**RE: REZ2025-00023, CUP2025-00016, and SE2025-00023
(Marchetti Properties, et al./VALCO Hanover County Four, L.L.C) – Comment Letter**

**Re: REZ2025-00023 - Marchetti Properties, LLC – Mountain Road Technology Park
(Rezoning)**

Date:	10-16-2025
Subject:	MARCHETTI PROPERTIES ET AL
Jurisdiction:	Hanover
Trakit File #	REZ2025-00023
From:	Lieutenant Paul Polivka Phone: 804-365-4858 Email: ptpolivka@hanovercounty.gov
To:	Gretchen Biernot
Type of Review:	Rezoning 1st Review
Comments:	• The Hanover Office of the Fire Marshal has completed its review of the Rezoning of this property and has the following comments as the project advances. 1. The submitted plan shall indicate the location of all required or existing fire hydrants after determining the number and distribution of fire hydrants: <i>VSFPC - C105.1 (2012)</i> 2. The average spacing between Fire hydrants shall not exceed that listed in <i>VSFPC - C105.1. (2012)</i>, 3. Fire hydrants must be located within 400 feet of all parts of the building: <i>VSFPC - 507.5.1 (2021)</i> 4. Provide details on the method to access all exterior points of the building from within 150 feet of an approved emergency fire apparatus access roadway. A

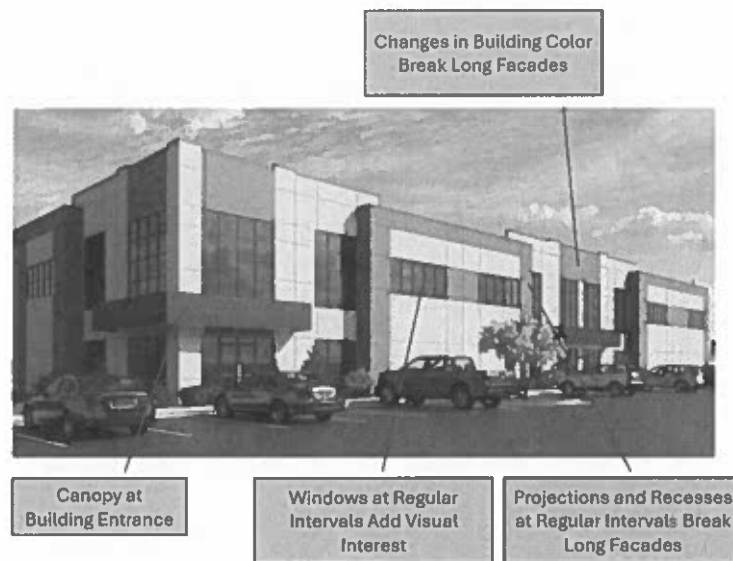
- a. On the conceptual site layouts (Conceptual Plan: Sheet C3.3), it would be helpful to note where generator yards will be located, with siting between buildings preferred. Do the light gray strips adjacent to buildings note generator yards?
- b. Please demonstrate how the conceptual site layouts conform with Proffer #5.e.ii, which states that “primary building facades and entrances should face internal streets, drive aisles, or campus circulation areas and be clearly visible and accessible.” Based on the parking locations, it does unclear if the conceptual site layouts demonstrate building layouts that can meet that requirement.
